**SOUTH  
KESTEVEN  
DISTRICT  
COUNCIL**

### S22/1865

**Proposal:** Proposed courtyard areas, walls, gates and blocking up of existing opening to Cheyne Lane. Works associated with S19/2237.

**Location:** Land Adjacent 3, 5, 22, 24 & 25 Stamford Walk and 16 St Marys Street, Stamford, PE9 2DF

Courtyard Floor Plan

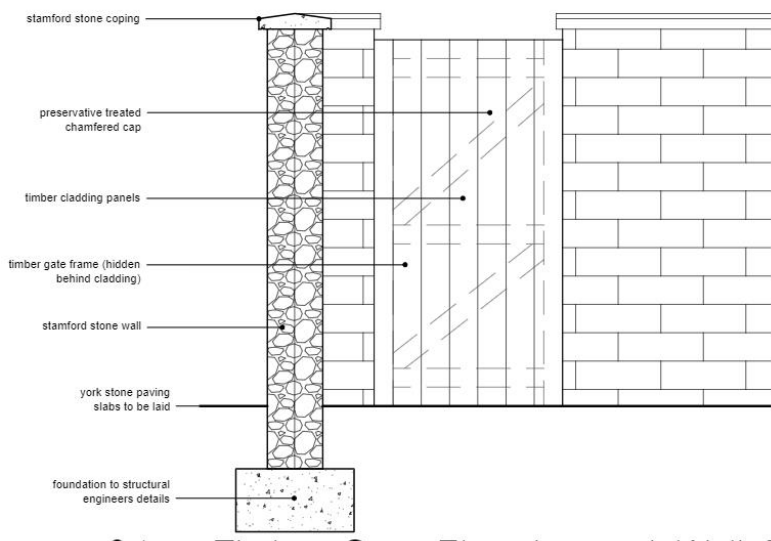
I am in receipt of amended details to the above which now show a re-aligned and more ordered layout to the proposed boundary walls to be erected at the rear of the building. The walls are also now to be more appropriately constructed in stone with stone copings. The view of the rear of the Hotel from the pedestrian area to the north will now be attractively presented. I note however that the section of wall enclosing the Town House courtyard is still specified to be in brick – I assume this is an oversight on the plans. Also, the site location plan still shows the boundary walls in their original position. Perhaps amendments to the plans to clarify these points should be requested – not least for the avoidance of doubt.

5.1.2 The existing opening onto Cheyne Lane appears to be a modern alteration to the original wall - there is a concrete lintol over the opening and the reveals appear to be comparatively recently formed. In my opinion, if it is confirmed that the opening can be blocked, this would be better carried out in matching stone coursed through with the existing, with the lintol removed.

The points previously raised have now been dealt with.

- 7.2.7 Following comments from the SKDC Conservation Consultant on the original proposal, it was considered that the proposed layout and the proposed dividing walls to be erected within the rear courtyard to the building were not satisfactory and amended plans were submitted. The latest version of plans provided show a less complex and sprawling design, with the realignment now being in a more ordered fashion, with stone walls and copings, and timber gates. SKDC's Conservation Consultant confirmed there are now no objections to this scheme as these plans address the previous concerns in terms of appearance and layout. It is considered that this design better respects the layout of this area and now results in minimal intrusion whilst still providing the desired amenity space the proposal relates to.

- 7.2.8 The proposed blocking up of the existing opening in the wall in Cheyne Lane is considered acceptable given that the proposal is for the works to be carried out in matching materials and it has been noted that the information provided by the applicant suggests the opening is of 20<sup>th</sup> Century modern construction and is not of historic significance.
